CRMC DECISION WORKSHEET

2023-11-073

STATE OF RHODE ISLAND
COASTAL RESOURCES MANAGEMENT COUNCIL
STAFF REPORT TO THE COUNCIL

Applicant's Name:	Amy Tourangeau
CRMC File Number:	2023-11-073
Project:	To c/m a residential boating facility (pier, ramp, float) extending 50' seaward of the cited MLW mark, requiring a 3" water depth variance
Location:	1 Lafayette Avenue; South Kingstown: Plat(s): 43-4; Lot(s): 6
Water Type/Name:	2, Narrow River (South Kingstown), Low Intensity Use
Coastal Feature:	Coastal wetland/seawall
Plans Reviewed:	"Dock Plan..Amy L. Tourangeau, AP 43-4, Lot 6, South Kingstown.." dated Nov. 16, 2023 as last revised 4/11/24 by Mark L. Dowdell, RPE
Staff Recommendation:	No technical objection, defer for consideration of objectors' comments

Figure 2, 1 Lafayette Ave, subject lot highlighted, Google Map satellite view:

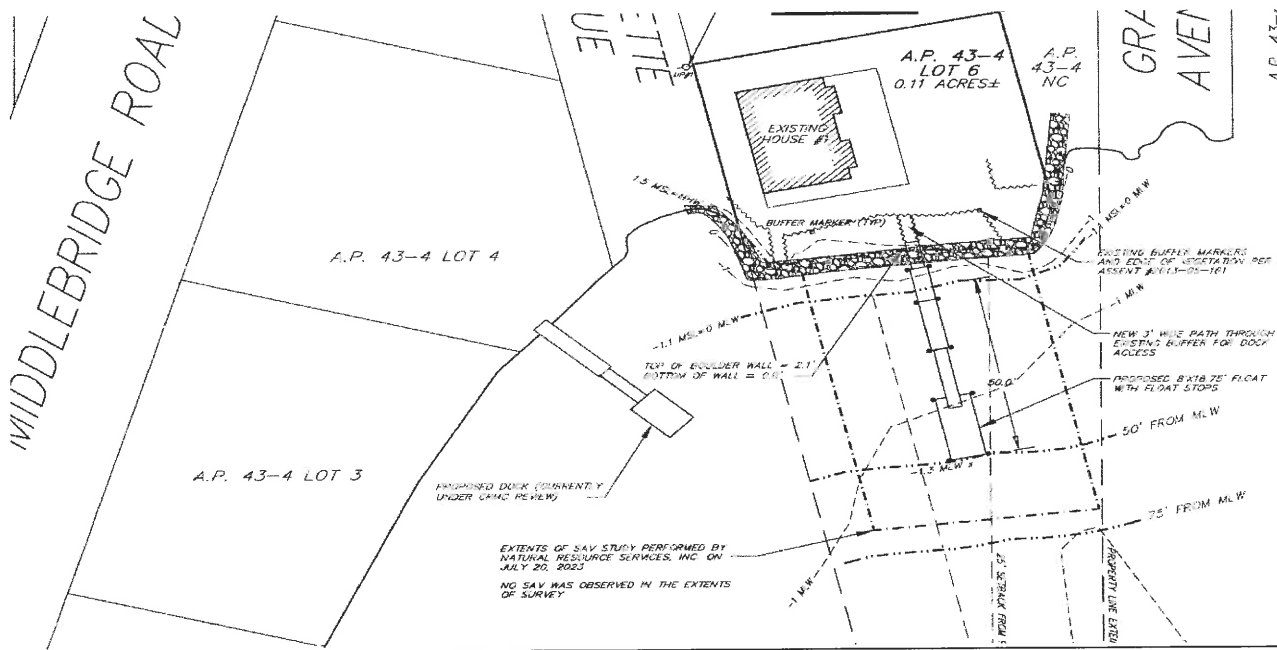
1— The project site is located on the western side of the Narrow River, just north of the Middle Bridge. It is bound by the terminus of Lafayette Ave to the south and residential development to the north/west. The end of Lafayette Ave is commonly utilized as a boat launching site (Figure 1). The rebuilt dwelling was approved by 2013-5-161. An existing grandfather dock was recently permitted for rebuilding on AP 43-4 Lot 4, just south of the ROW and permitted docks exist further north (Figure 2). An informal channel is present in the River which is used to navigate through the Middle Bridge, avoiding sandbars/shallows.
